ORIEL WIND FARM PROJECT

Environmental Impact Assessment Report - Addendum Appendix 28-3: Design Report

MDR1520C
EIAR – Appendix 28-3
A1 C01
December 2025

Stage 1 Road Safety Audit

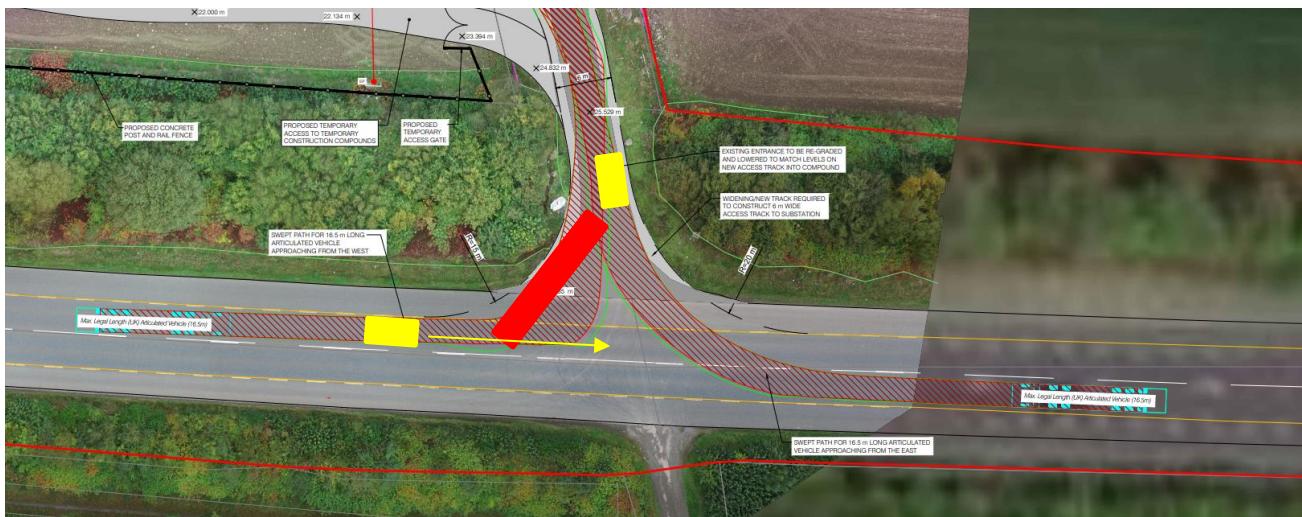
ORIEL WIND FARM PROJECT: N33 ONSHORE CABLE INSTALLATION**4.2 Problem 4.2****Location:** Scheme wide**Summary:** Restricted Visibility of existing farm entrances

Some of the existing farm entrances along the N33 appeared to have restricted visibility. If these accesses are to be used for construction or maintenance of the cable routes, there is a risk of side-on or rear-end collisions between N33 traffic and construction vehicles exiting these assesses.

It is recommended an assessment of visibility to be carried out for these site entrances if construction and maintenance access is required.

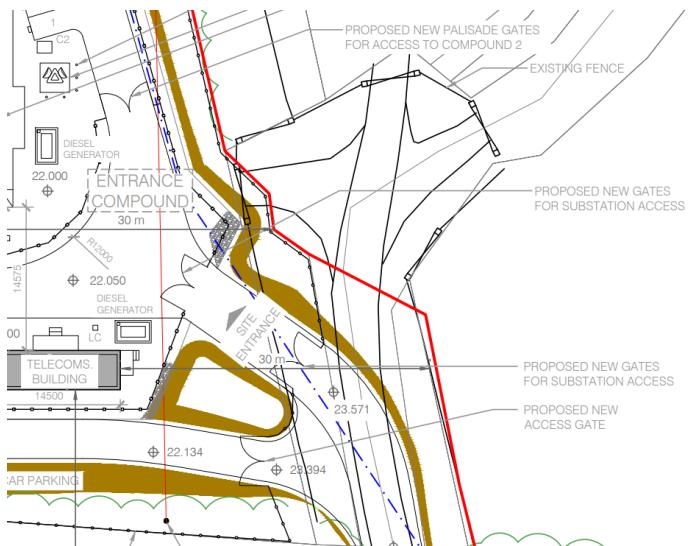
Summary: Articulated HGV entering the substation partially blocking the eastbound lane of N33

At the proposed site entrance at the substation, the proposed widened track appears to be of insufficient width to accommodate two-way vehicular movements. In the situation that a HGV entering the site encounters the oncoming traffic exiting the farm/the substation, the HGV may be partially blocking the N33 eastbound carriageway lane to yield to oncoming traffic. This could lead to rear-end collision between N33 eastbound traffic and the yielding HGV, or head collision if traffic swerves to avoid the yielding HGV and crosses into the opposing N33 lane.

The access arrangements should be designed so as to provide adequate facilities to ensure that the all vehicles turning into the substation entrance will not impede in anyway, the N33 traffic.
